**CONCORD PUBLIC WORKS  
ENGINEERING DIVISION**

**MEMORANDUM**

**TO:** Elizabeth Hughes, Town Planner  
**COPY:** Alan Cathcart, Director of Public Works  
**VIA:** Steve Dookran, P.E., Town Engineer  
**FROM:** Justin Richardson, P.E., Assistant Town Engineer  
**SUBJECT:** 48Y Fitchburg Turnpike: ZBA Special Permit

Concord Public Works (CPW) Engineering Division has reviewed the ZBA Special Permit Application, Plans, Calculations and Reports for 48Y Fitchburg Turnpike prepared by Civil Design Group, LLC, dated June 9, 2022 from the Applicant Quarry North Road LLC. The Engineering Division offers the following:

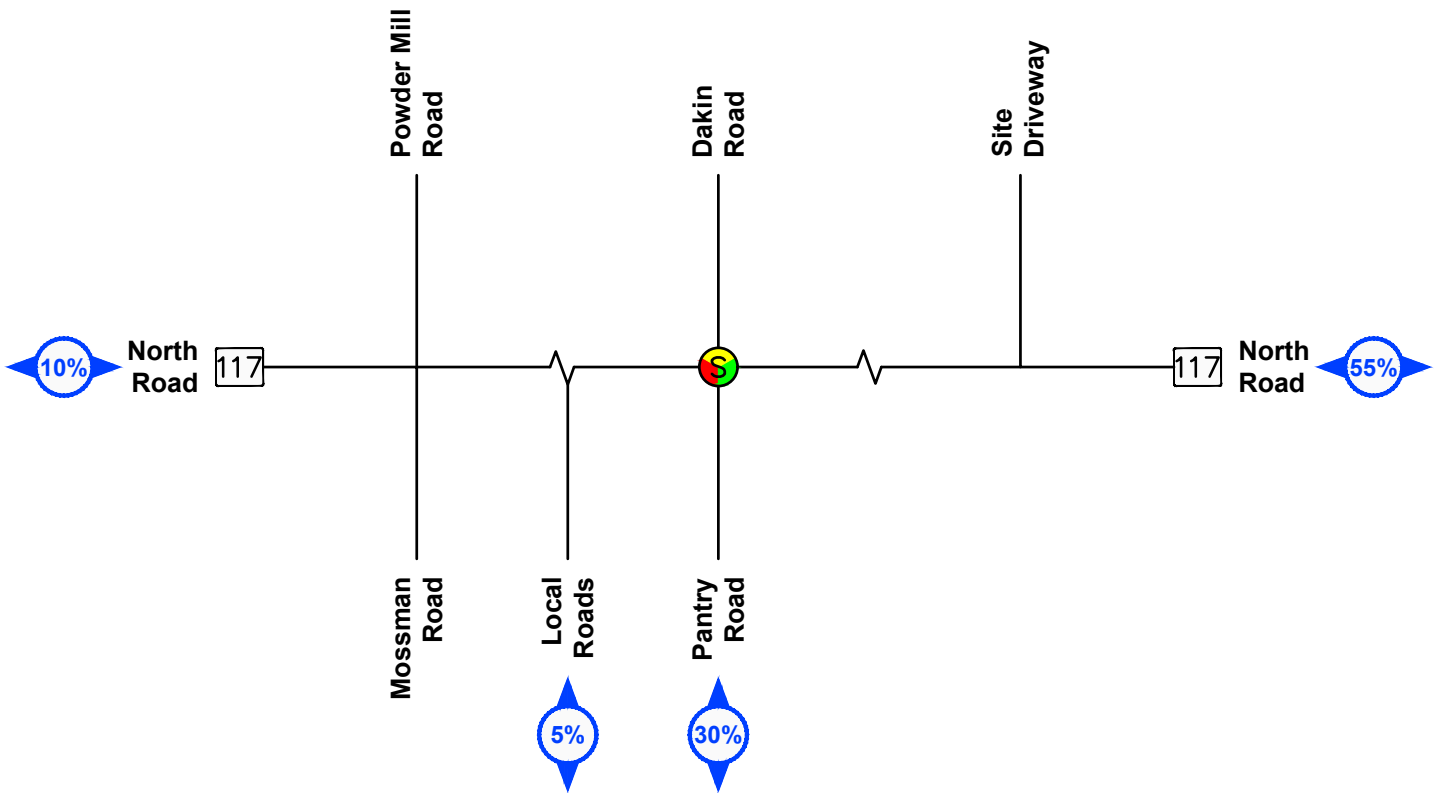
2. The traffic analysis provided indicates an increase in traffic, but it is unclear how much of the increased traffic will be traveling eastbound into the Town of Concord. Please include that information in the traffic analysis. **55% of the traffic generated will go east when leaving. See attached figure from MDM TIAS.**
